Evaluation of a proposal for reliable low-cost grid power with 100% wind, water, and solar

Evaluation of a proposal for reliable low-cost grid power with 100% wind, water, and solar

Edited by B. L. Turner, Arizona State University, Tempe, AZ, and approved February 24, 2017 (received for review June 26, 2016)

Fig. 1. This figure (figure 4B from ref. 11) shows hydropower supply rates peaking at nearly 1,300 GW, despite the fact that the proposal calls for less than 150 GW hydropower capacity. This discrepancy indicates a major error in their analysis. Modified from ref. 11.

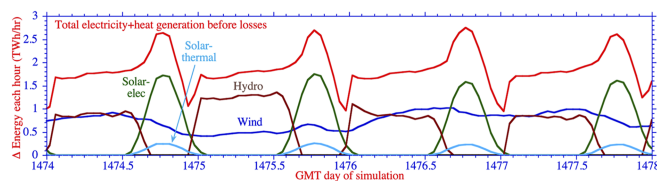
As we detail in *SI Appendix, section S1*, ref. 11 includes several modeling mistakes that call into question the conclusions of the study. For example, the numbers given in the supporting information of ref. 11 imply that maximum output from hydroelectric facilities cannot exceed 145.26 GW (*SI Appendix, section S1.1*), about 50% more than exists in the United States today (15), but figure 4B of ref. 11 (Fig. 1) shows hydroelectric output exceeding 1,300 GW. Similarly, as detailed in *SI Appendix, section S1.2*, the total amount of load labeled as flexible in the figures of ref. 11 is much greater than the amount of flexible load represented in their supporting tabular data. In fact, the flexible load used by LOADMATCH is more than double the maximum possible value from table 1 of ref. 11. The maximum possible from table 1 of ref. 11 is given as 1,064.16 GW, whereas figure 3 of ref. 11 shows that flexible load (in green) used up to 1,944 GW (on day 912.6). Indeed, in all of the figures in ref. 11 that show flexible load, the restrictions enumerated in table 1 of ref. 11 are not satisfied.

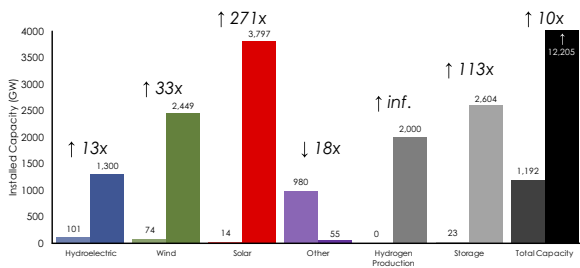
The 100% wind, solar, and hydroelectric power system study (11) also makes unsupported assumptions about widespread adoption of hydrogen as an energy carrier, including the conversion of the aviation and steel industries to hydrogen and the ability to store in hydrogen an amount of energy equivalent to more than 1 month of current US electricity consumption. Furthermore, in figure S6 of ref. 11, hydrogen is being produced at a peak rate consuming nearly 2,000 GW of electricity, nearly twice the current US electricity-generating capacity. As detailed in *SI Appendix, section S2.3*, the costs and feasibility of this transition to a hydrogen economy are not appropriately accounted for by ref. 11. To show the scale of the additional capacities that are demanded in refs. 11 and 12, we plot them along with the electricity generation capacity in 2015 in Fig. 2. The data used for Fig. 2 can be found in *Datasets S1* and *S2*.

Fig. 2. Installed capacity values for 2015 (left column in each pair) and those used in the studies in refs. 11 and 12 (right column in each pair). These 100% wind, solar, and hydroelectric studies propose installing technologies at a scale equivalent to (or substantially greater than) the entire capacity of the existing electricity generation infrastructure. The other category includes coal, natural gas, and nuclear, all of which are removed by 2050.

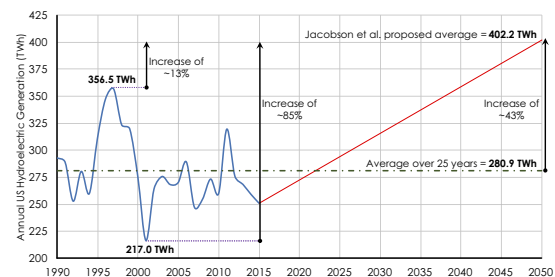
To illustrate the implausibility of the assumed increase in hydroelectric net generation (dispatched from the plants to the electricity grid) in the face of limited water supply, we plot in Fig. 3 the last 25 y of generation from hydropower in the United States along with the average for the studies in refs. 11 and 12. The data used for Fig. 3 can be found in *Datasets S1* and *S2*. Average future generation assumed by refs. 11 and 12 is 13% higher than the highest peak year in the last 25 y and 85% higher than the minimum year in the last 25 y. Therefore, in addition to needing 1,300 GW of peak power from 150 GW of capacity, there also needs to be an extra 120 TWh of hydroelectric gener-

Fig. 3. Historical and proposed hydroelectric generation per year. The historical data (www.eia.gov/todayinenergy/detail.php?id=2650) show generation averaging 280.9 TWh/yr; generation proposed in ref. 11 is 402.2 TWh, 13% higher than the 25-y historical maximum of 356.5 TWh (1997) and 85% higher than the historical minimum of 217 TWh (2001).

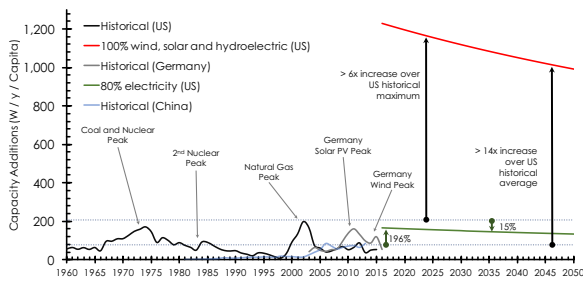
In Fig. 4, we display another metric on the scale of expansion. It shows the rate of installation as watts per year per capita. Using this metric, we can compare the scale of capacity expansion in ref. 11 with historical data. Fig. 4 shows that the plans proposed in refs. 11 and 12 would require a sustained installation rate that is over 14 times the US average over the last 55 y and over 6 times the peak rate. For the sake of comparison, Fig. 4 includes the estimated rate for a solution that decarbonizes the US electric grid by 78% by 2030 (1), historical German data, and historical Chinese data. We note that ref. 1 considered large-scale storage but excluded it based on preliminary results showing that it was not cost-effective compared with a national transmission system. The data used for Fig. 4 can be found in *Datasets S1* and *S2*. Sustaining public support for this scale of investment (and this scale of deployment of new wind turbines, power lines, etc.) could prove challenging. One of the reasons that this buildout may prove difficult is that the 100%

Fig. 4. The historical rates of installed electric-generating capacity per capita (watts per year per capita) for China (blue), Germany (gray), and the United States (black) are shown with the estimated values for the US proposals from the works by Jacobson et al. (11, 12) (red) and MacDonald et al. (1) (green). It shows that the 100% wind, solar, and hydropower power plan requires installation of new capacity at a rate more than an order of magnitude greater than that previously recorded in China, Germany, or the United States. The rate would have to be continued indefinitely because of replacing generation as it aged.
